#89-260-6A: SERPENTINE BELT W/WORN IDLER PULLEY OR TENSIONER - (Aug 31, 1989)

Model and Year: 1987-89 C, K, R, V, S, T TRUCKS AND M, G VANS WITH 4.3L, 5.0L, 5.7L, 7.4L (VIN CODE Z, H, K, N) ENGINES

[Figure 1](#)

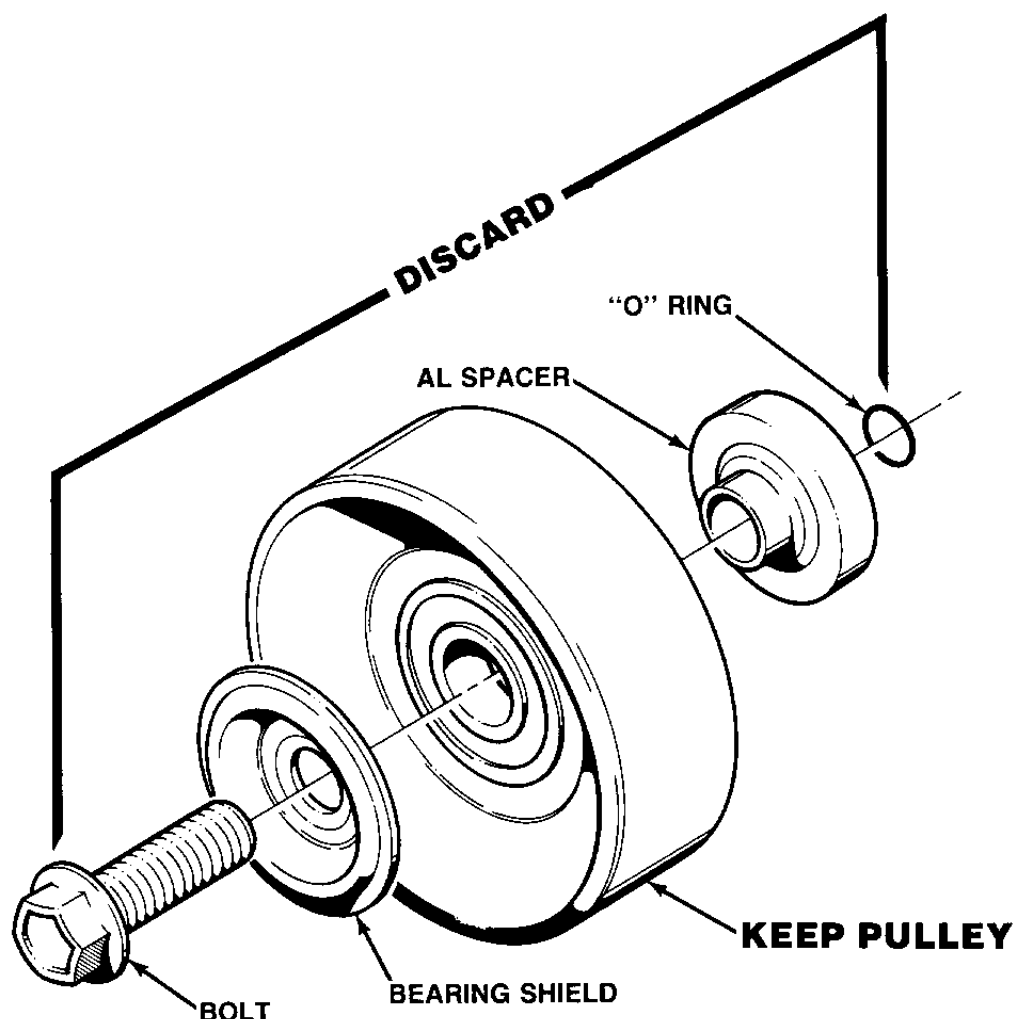
1. Using procedures in 6B-Engine Cooling, remove and discard the serpentine belt.
2. On trucks with 4.3L, 5.0L, 5.7L and 7.4L engines, using metal pulley (P/N 10129561) perform the following steps:
 - A. Remove O-ring, aluminum spacer, bolt, and metal bearing shield and discard (see illustration).
 - B. Retain the metal pulley.
3. With tensioner on engine, remove worn tensioner pulley, bolt, and metal bearing shield. Discard pulley and retain bolt and shield for reassembly.

IMPORTANT: 4.3L, 5.0L, and 5.7L bolt have left-hand threads.

7.4L bolt has right-hand threads.

4. Install new metal pulley and the original shield and bolt on the tensioner.
5. Install new serpentine belt.
